Coolant Level Sensor, Replacement MRU, LEU, LR

FSB 386-009, Coolant Level Sensor, Replacement

(May 2015)

W3094949

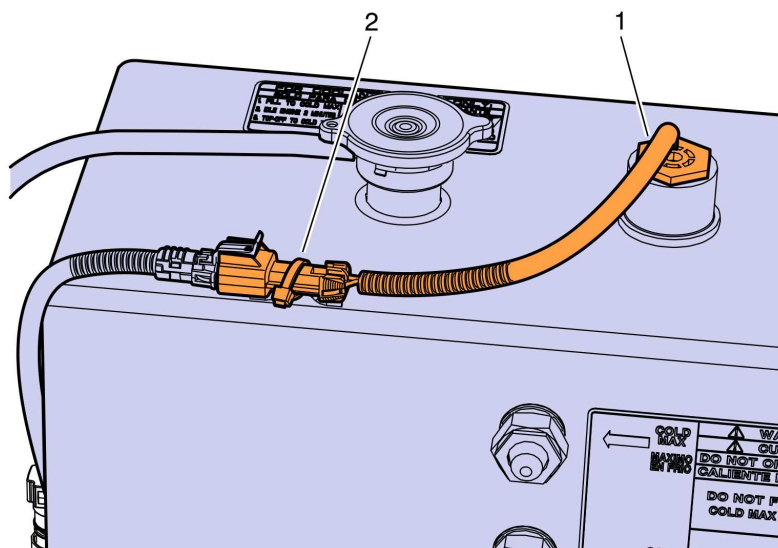
The coolant level sensor (part number 21257608) on some MACK cabover trucks built between 10/04/2008 and 02/20/2015 may fail internally. Failure of the sensor can cause the malfunction indicator light (MIL) to illuminate and can cause an unplanned stop in cases where the engine parameter "engine shutdown with low coolant" is enabled. To prevent further issues with false low coolant warnings, replace the coolant sensor with part number 22312907.

W3094953

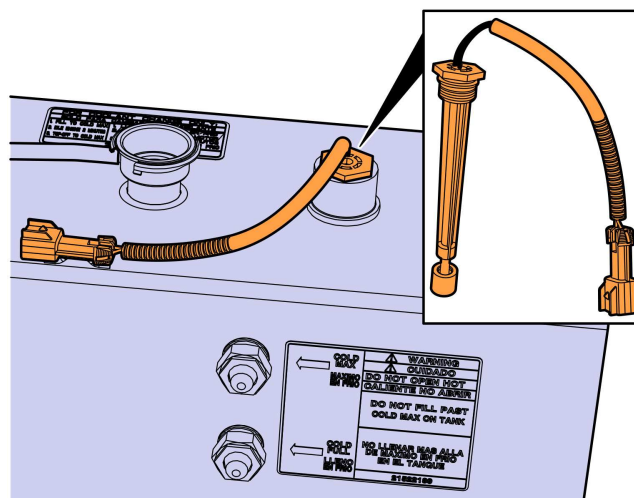
- 10 Install the new coolant level sensor (part number 22312907).
11 Using hand tools, tighten the coolant level sensor to 10 Nm (88 in-lb).
Note: Do not overtighten the coolant level sensor.
